ARCHITECTURAL REVIEW COMMITTEE MEMORANDUM

DATE: May 15, 2023

SUBJECT: REQUEST BY MCGEE SHARON ARCHITECTS ON BEHALF OF DESERT PRODUCTIONS LLC, FOR ARCHITECTURAL REVIEW APPLICATION TO CONSTRUCT A 10,959 -SQUARE FOOT WAREHOUSE FACILITY ON A 21,923-SQUARE FOOT UNDEVELOPED PARCEL LOCATED AT 200 OASIS ROAD (APN: 669-444-012, 669-444-011), ZONE M-1-SP, (CASE 3.2864 MAJ/DP). (SY)

PLANT KEY

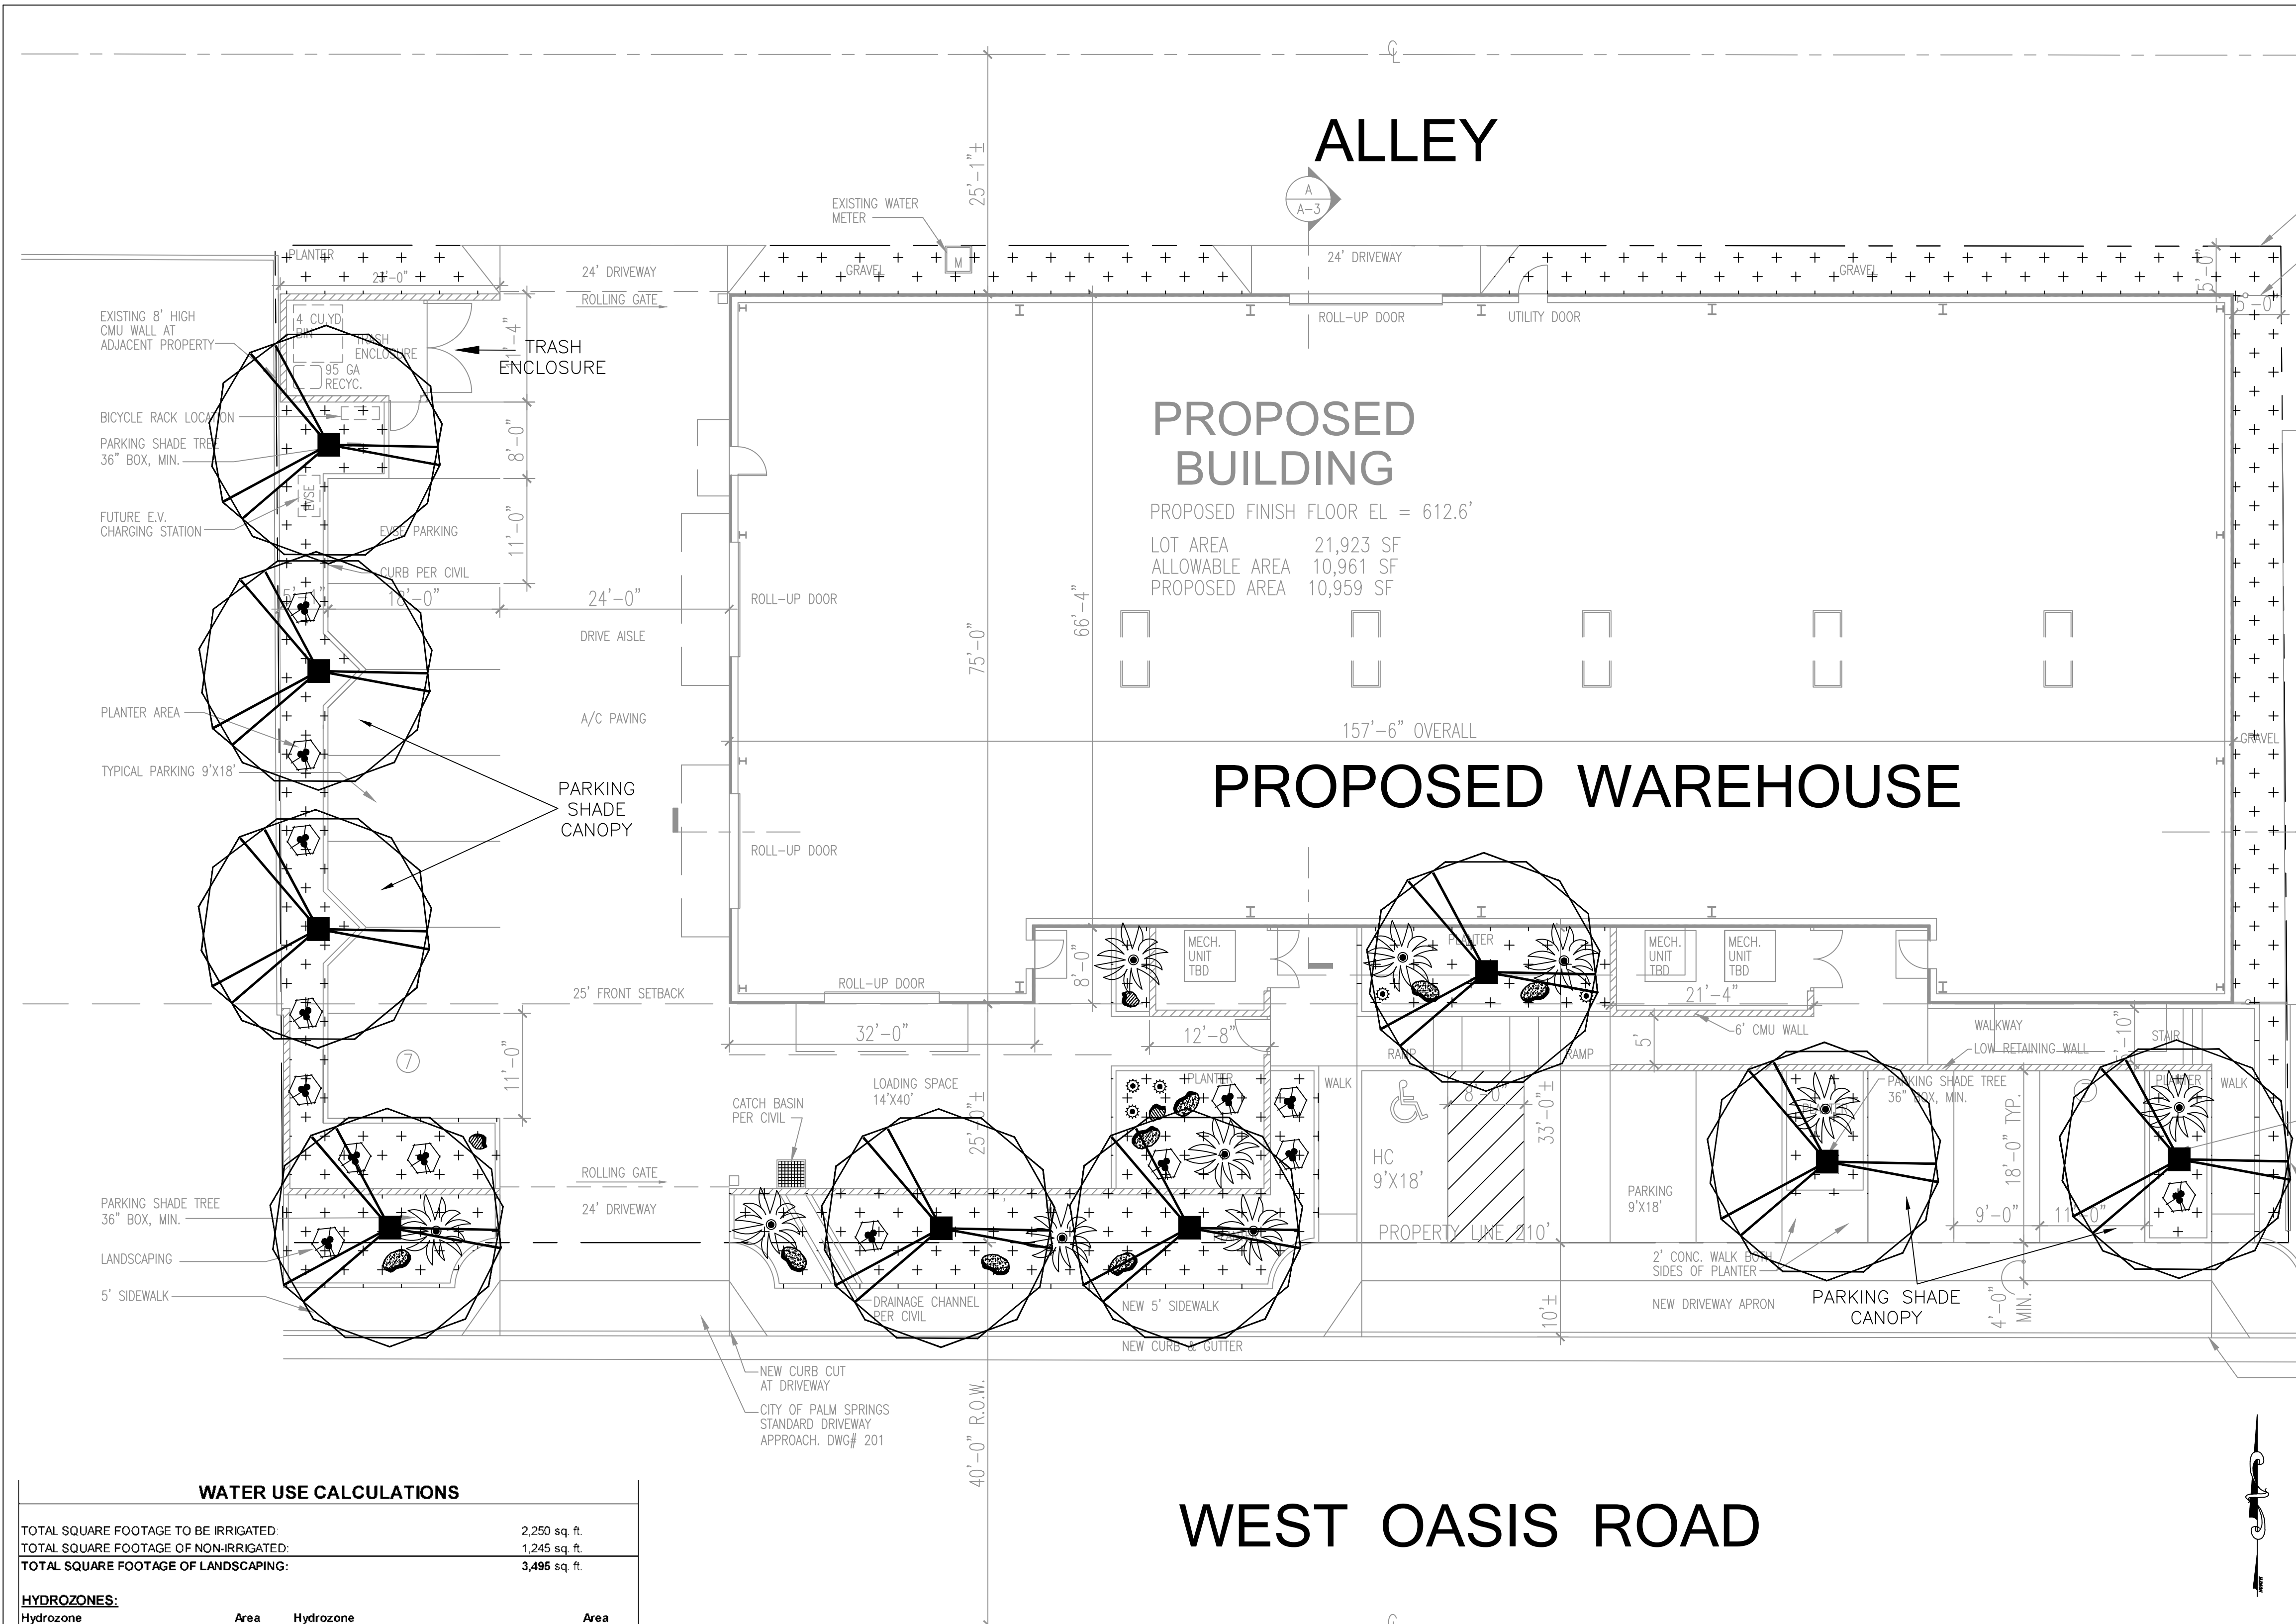
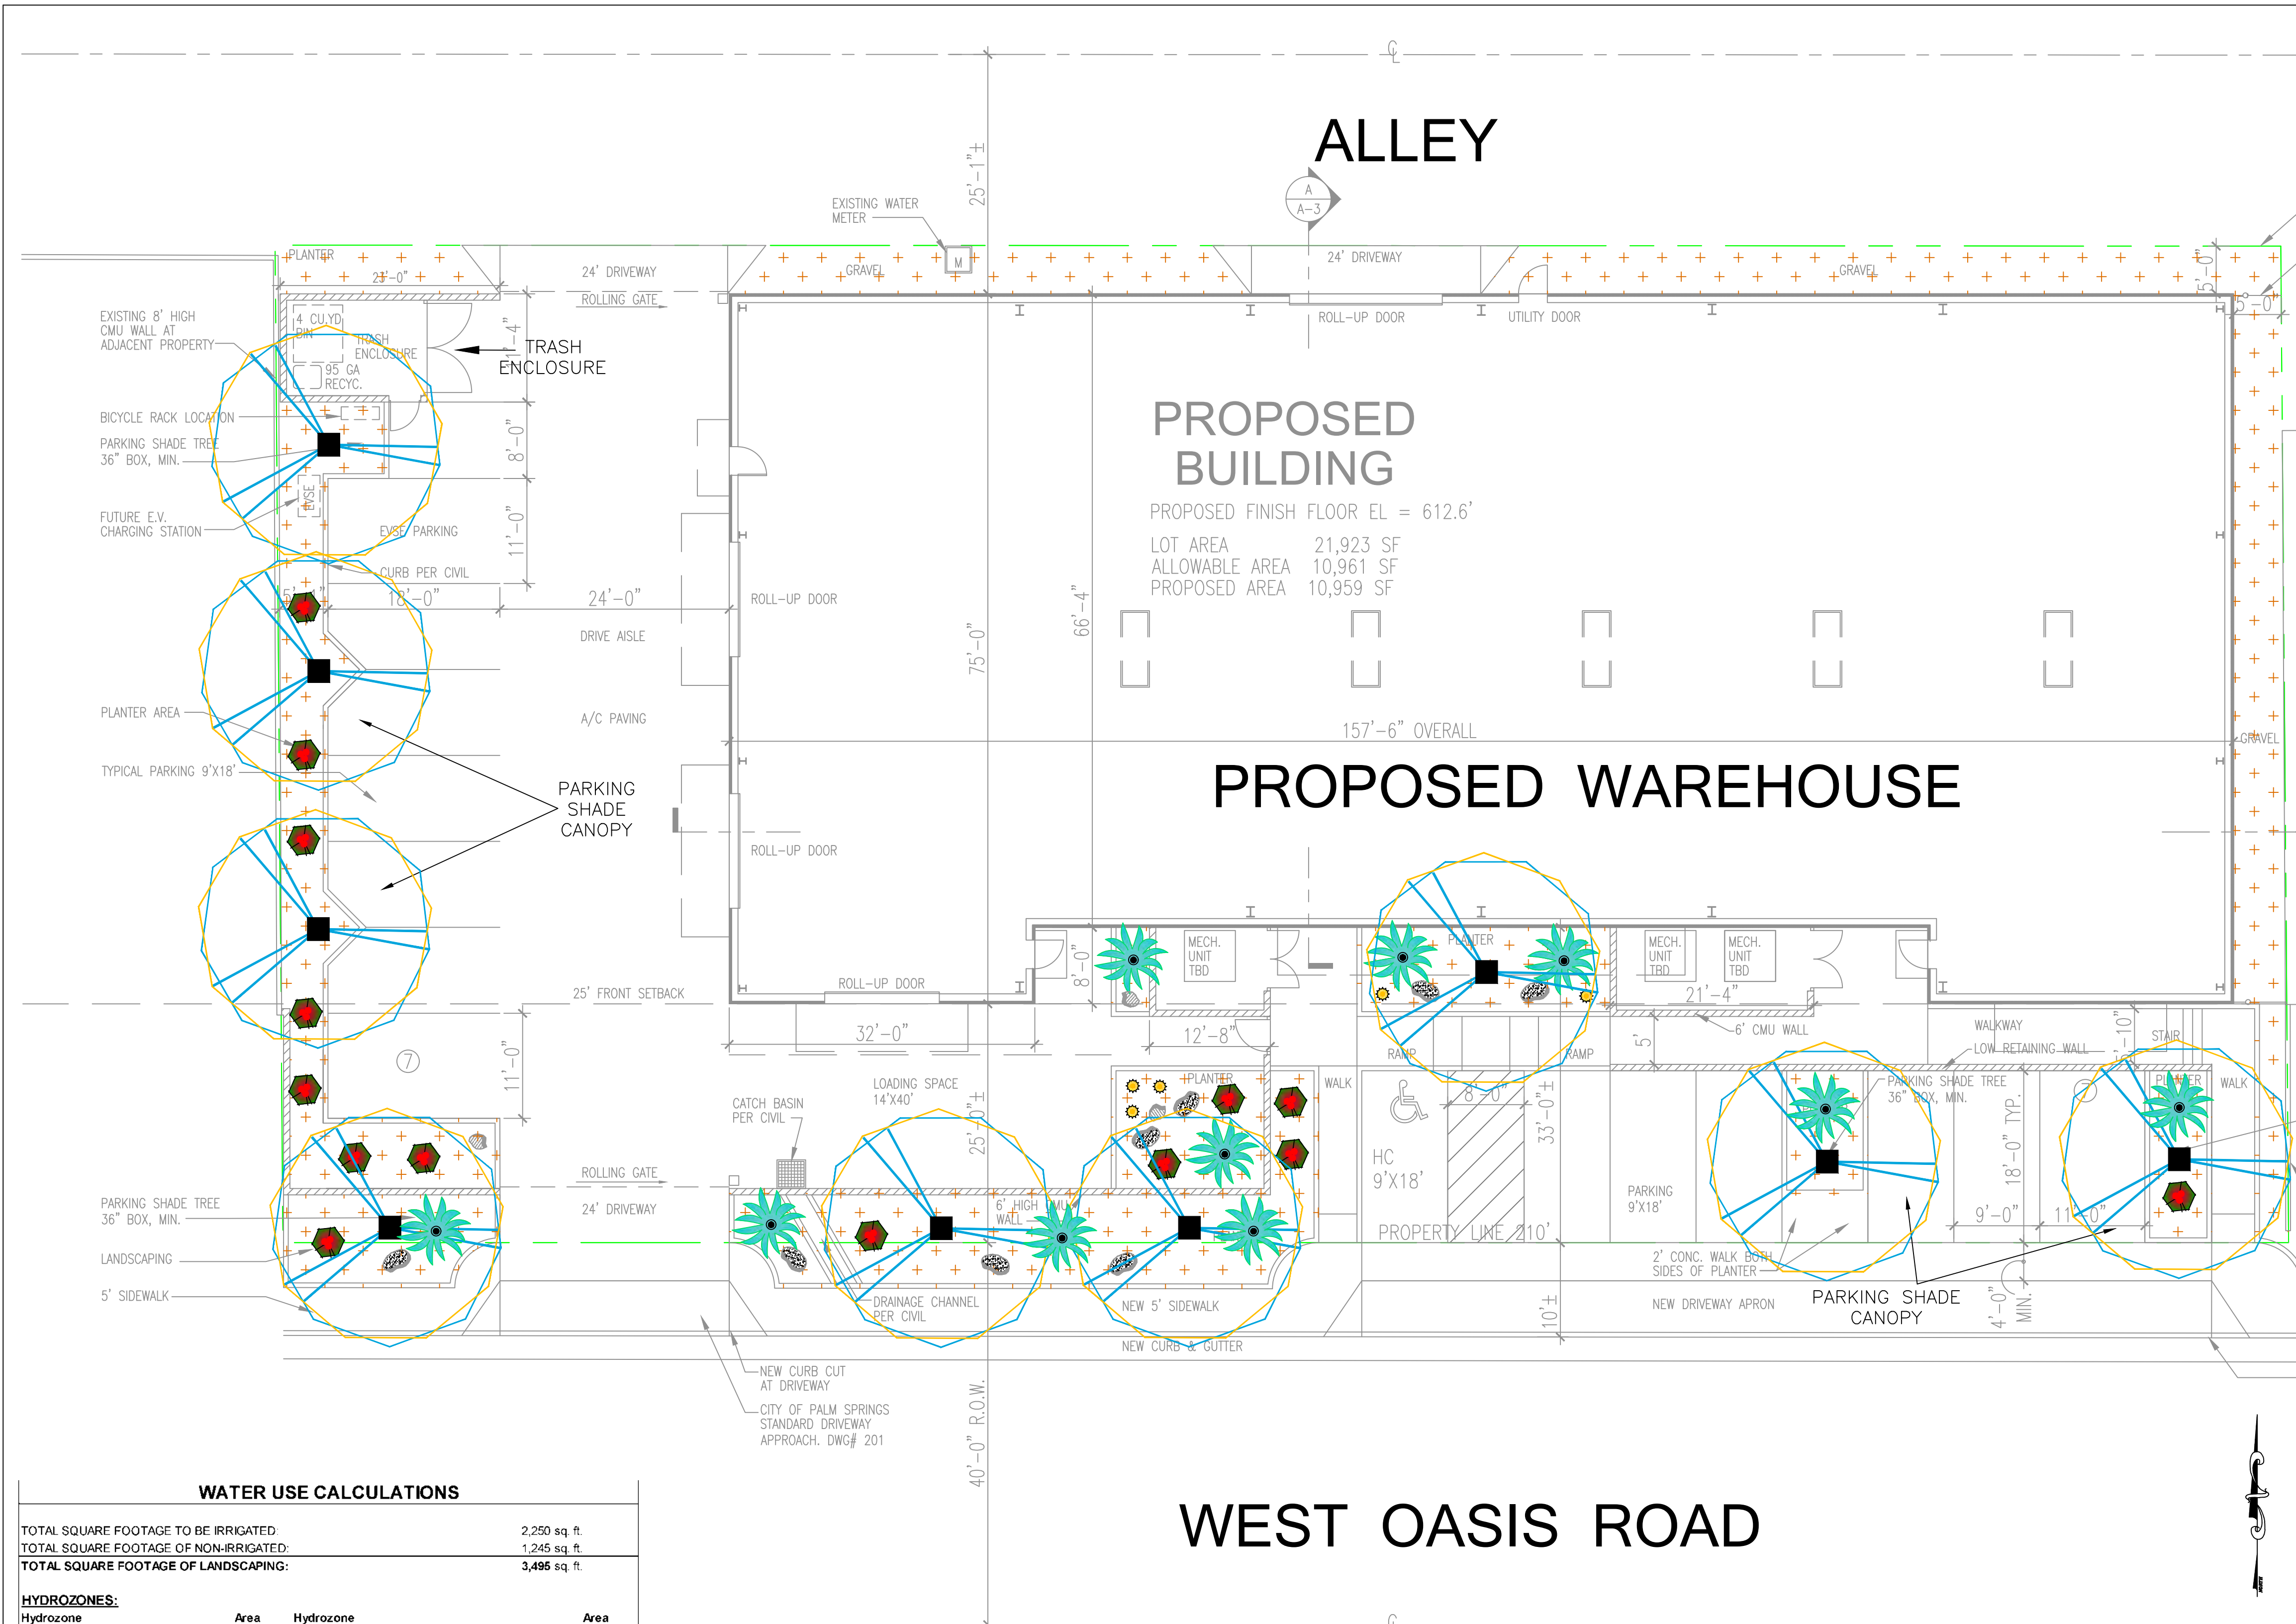
1. Pennisetum (Fountain grass) is considered an invasive grass that should not be permitted in the final landscape plan.
2. Reconsider the proposed tree species (Cercidum Floribunda – "Desert Museum" & Caesalpinia Cacalaco – "Smoothie") for ones that do not have blighted conditions and will better withstand windy conditions.
3. Hesperglloe parviflora (Red Yucca) should be located in an area with direct sun exposure.

7.	<p><i>The proposed landscape plan is consistent with the requirements of PSMC Chapter 8.60;</i></p> <p>The proposed planting schedule consists of plant materials that are included in the Lush and Efficient landscape gardening book. The Planning Commission provided additional recommendations regarding the proposed trees species listed above. 1" crushed rock is proposed as the ground coverage material and no turf will be installed. The landscape design is consistent with the Palm Springs Water Conservation Ordinance (PSMC Chapter 8.60) but will need to be approved by the DWA prior to building permit submission.</p>	Y

Planning Commission provided additional recommendations regarding the proposed trees species listed above. 1" crushed rock is proposed as the ground coverage material and no turf will be installed. The landscape design is consistent with the Palm Springs Water Conservation Ordinance (PSMC Chapter 8.60) but will need the landscape plan approved by the DWA prior to building permit submission.

A. Final landscape plan must be approved by the Desert Water Agency
